STAFF REPORT: 01-22-2020 MEETING

APPLICATION NUMBER: 20-6648

ADDRESS: 8116 - 8130 KERCHEVAL/THE KERCHEVAL 3

HISTORIC DISTRICT: WEST VILLAGE

DECK - FLOOR PLAN
1/8" = 1'-0"

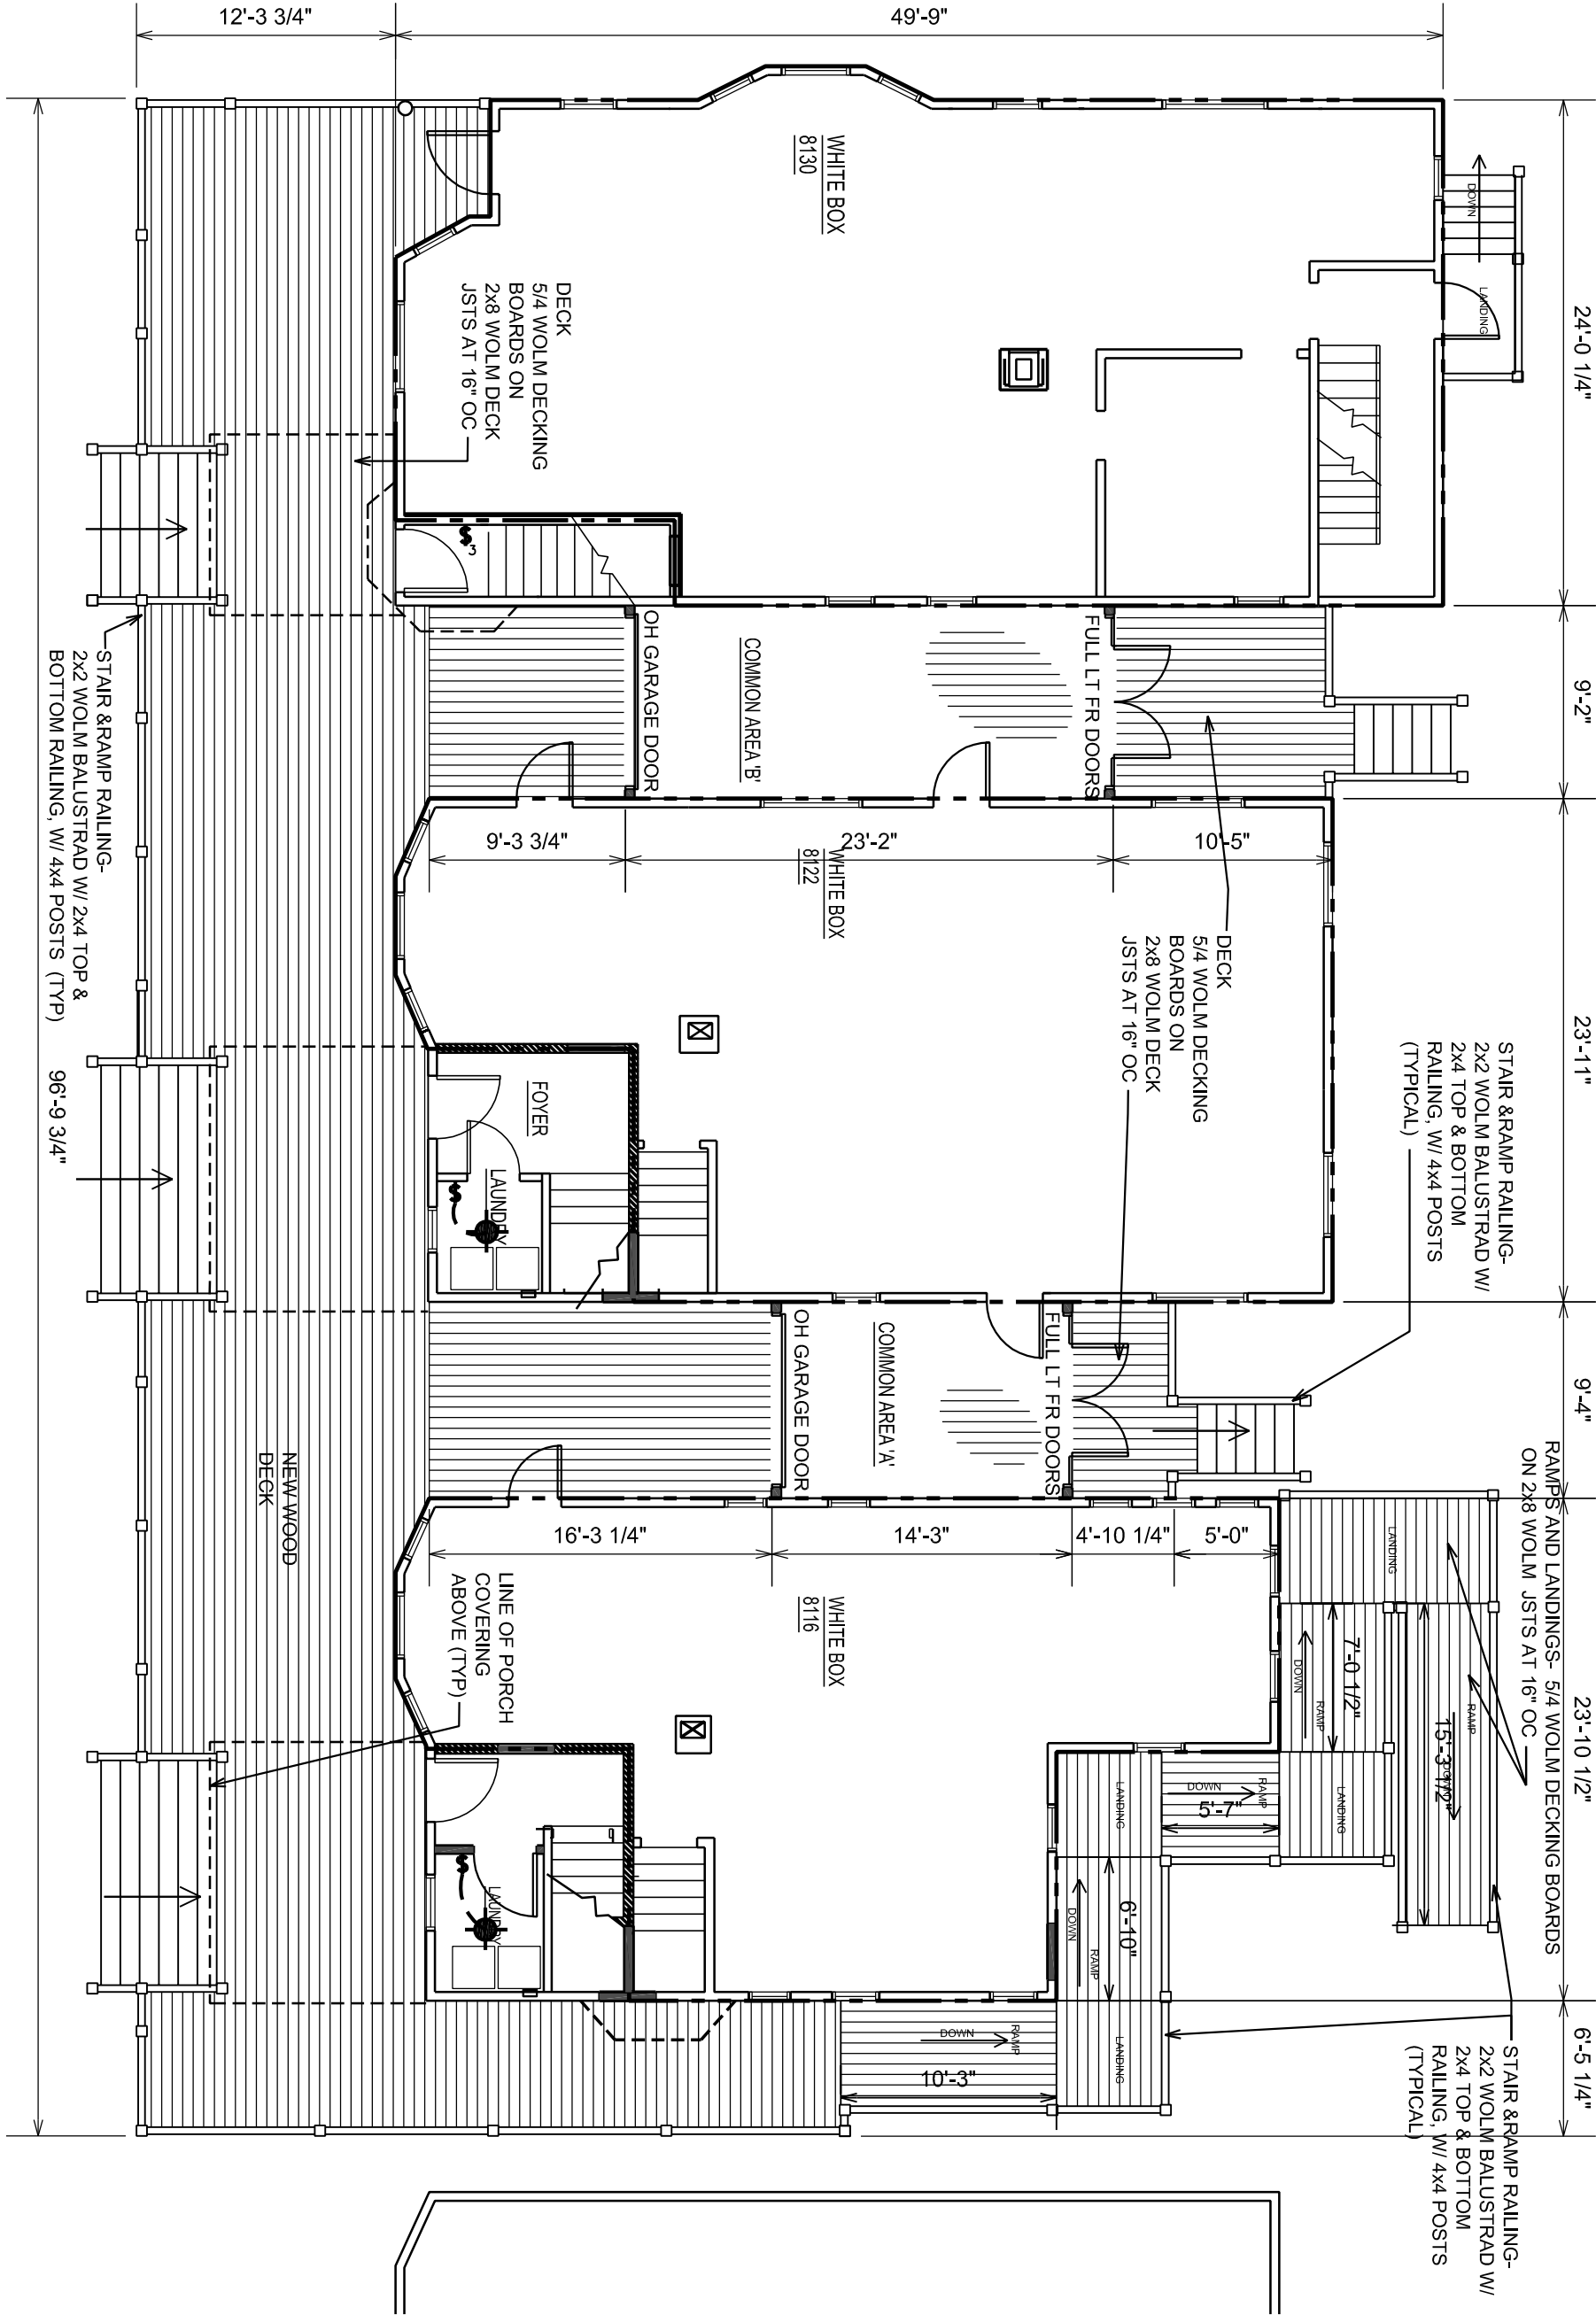
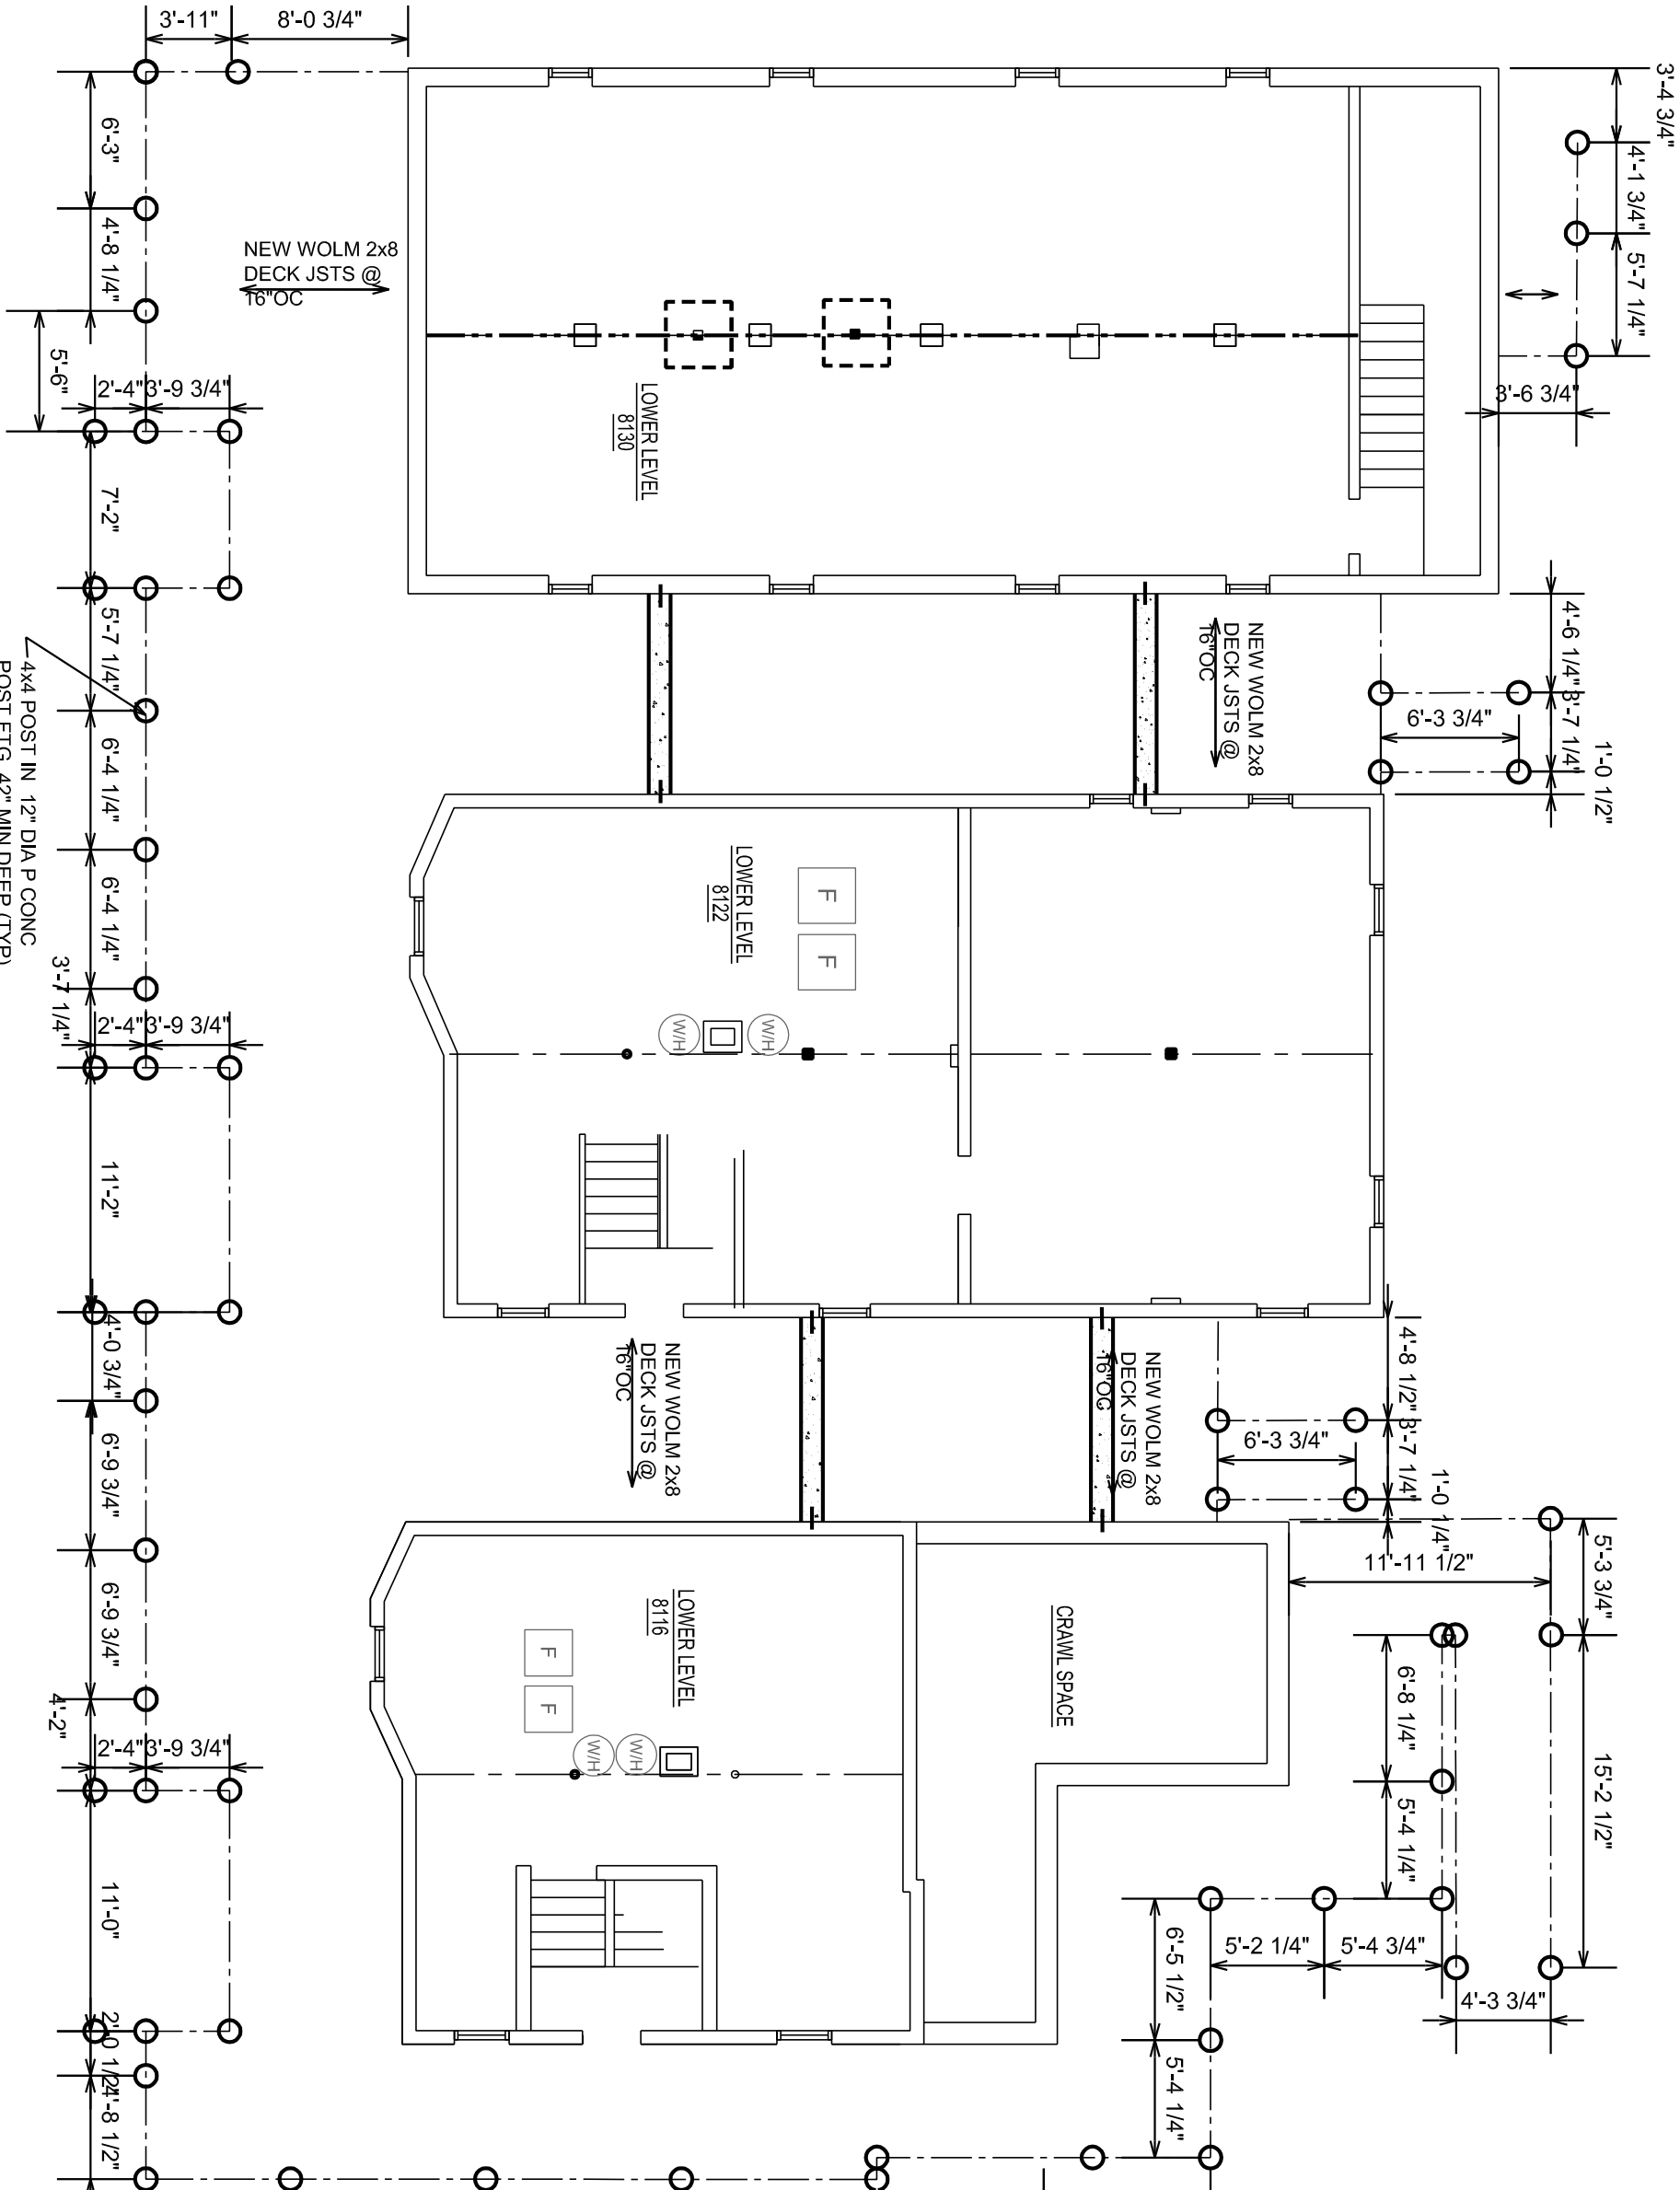
- Deck/Railing/Ramp: Per the Commission's prior approval, these elements were to be painted Colonial Revival Gray. Deadline for painting was August 16, 2018. These elements remain unpainted.

- Discussed during the initial project review, the elevated deck/railing/accessible ramp spanning the three residential structures was identified as a contemporary architectural element and approved as a unified design, which was to be painted one color (Colonial Gray) to match the wood siding so the contrasting color scheme on the three houses would be the dominant features of the development.

- The railing painted white makes it a highly visible feature on the front of the development, rather than a secondary one as intended by the HDC's 2017 conditional approval.
- The one window that was to remain on the second floor of the east elevation of 8122 was removed and completely sided over. Its absence has created a large blank wall, not in keeping with a historic structure, in staff's opinion.
- It is staff's opinion that vinyl windows are not compatible with the historic materials on the houses, nor are they appropriate within a local historic district. Additionally, the muntin patterns of the historic windows were altered.

- The deck, railing, deck enclosure and ramp shall be painted Colonial Gray as originally approved and will be completed no later than September 30, 2020.
- The wood fence enclosing the mechanical equipment will be painted gray to match the house, and it shall be completed no later than September 30, 2020.
- An outdoor seating/dining plan, including catalog cuts (or photographs) of all items will be submitted to HDC staff for review and approval on or before May 1, 2020.
- A landscape plan will be created for the front of each house and will be submitted to HDC staff for review and approval.

RIGHT SIDE (WEST) ELEVATION -8122

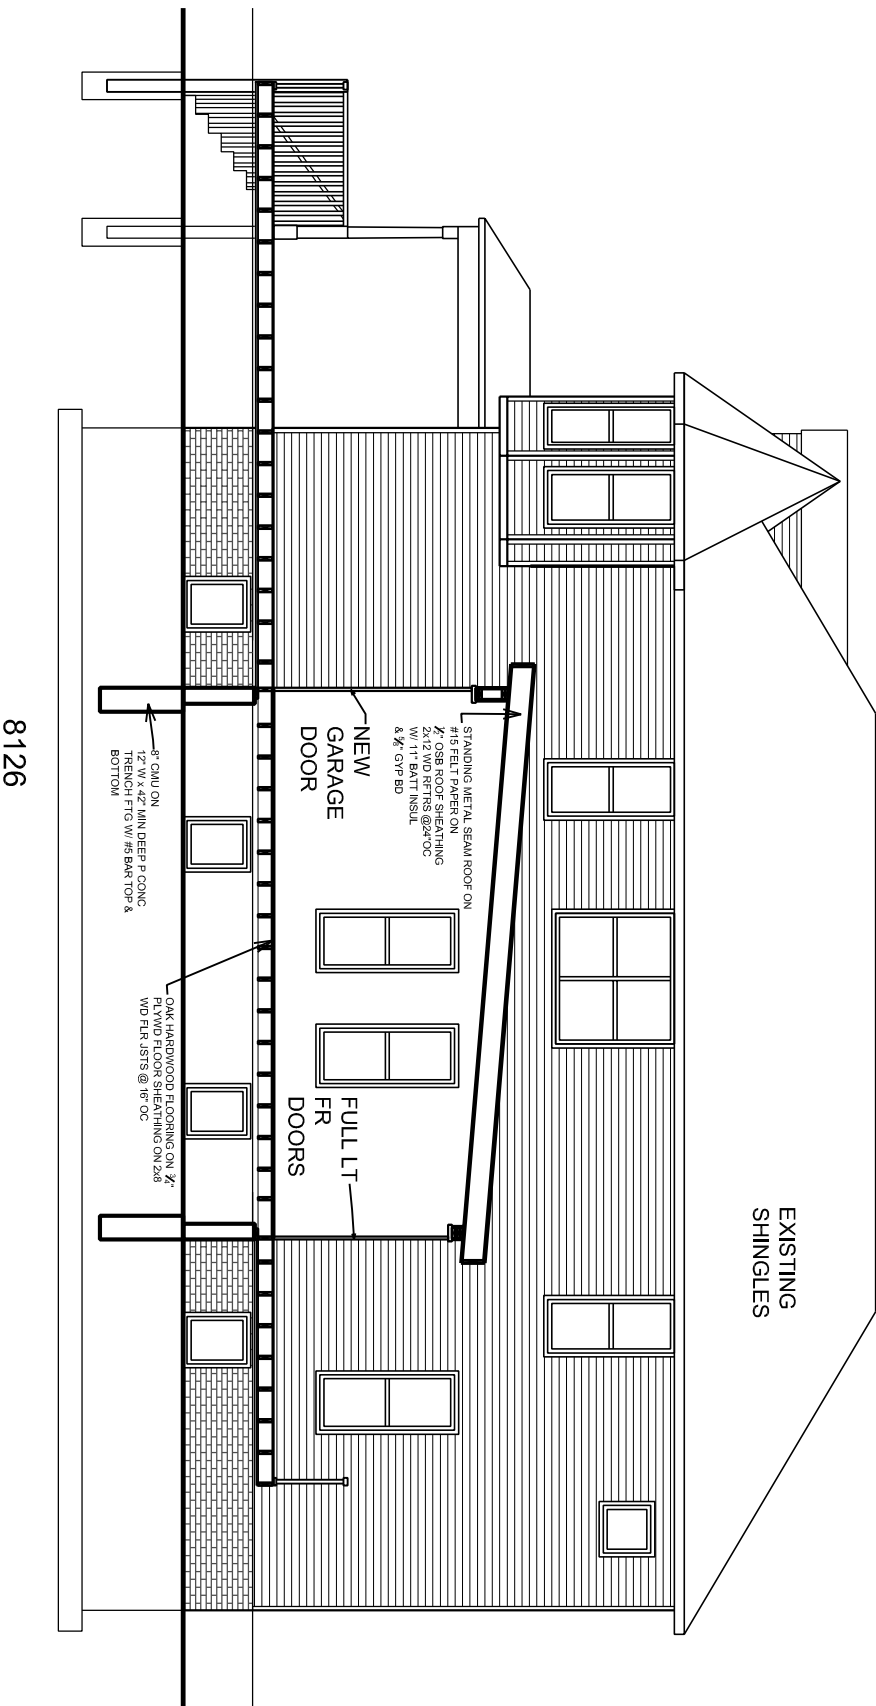
- 8122: A door was removed on the east elevation, and a door opening, closer to the rear, was added.
 - 8126-8130: Two windows were removed on the west elevation, near the middle of the structure. Two windows were shortened on the east elevation, toward the rear.

It is staff's opinion the removal of the west elevation, 2nd floor window at 8122 and the installation of vinyl windows at the three properties did destroy materials and features that characterize the historic character of the property. Staff therefore recommends the Commission deny an issuance of a COA for the window removal and the vinyl windows as the projects do not meet the Secretary of Interior Standards for Rehabilitation Standards, specifically:

LEFT SIDE (EAST) ELEVATION -8116

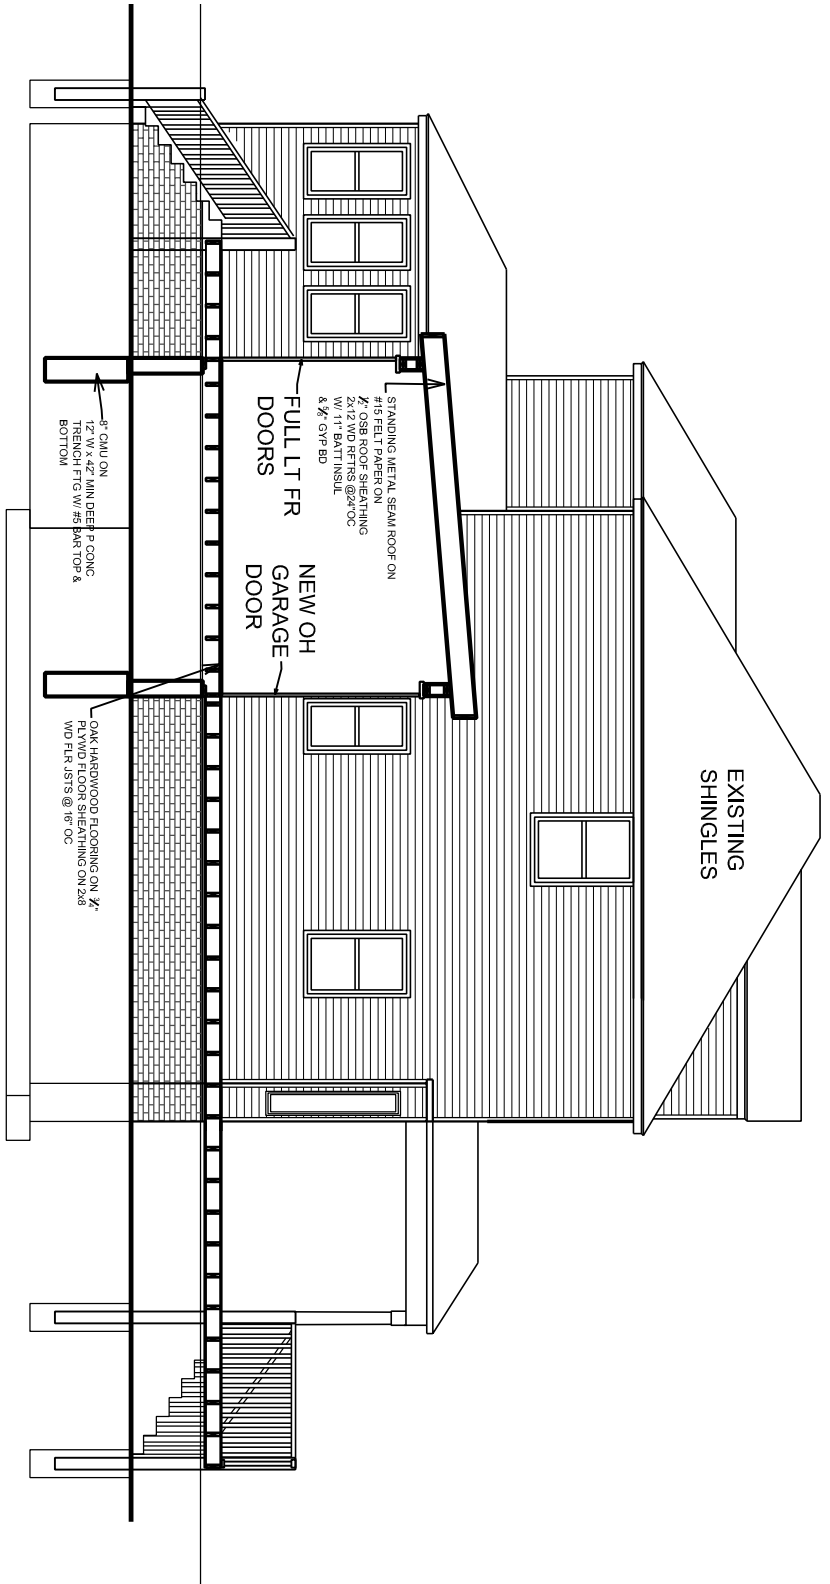
- 8116: One window on the west elevation (near the rear) was removed. Three windows on the east elevation (near the rear) were removed. The one window on the second floor of the west elevation that was to remain, was removed and completely sided over.

Three windows on the east elevation of 8116 Kercheval were covered with wood siding. Please refer to the plans from the 2017 review for documentation of the windows.
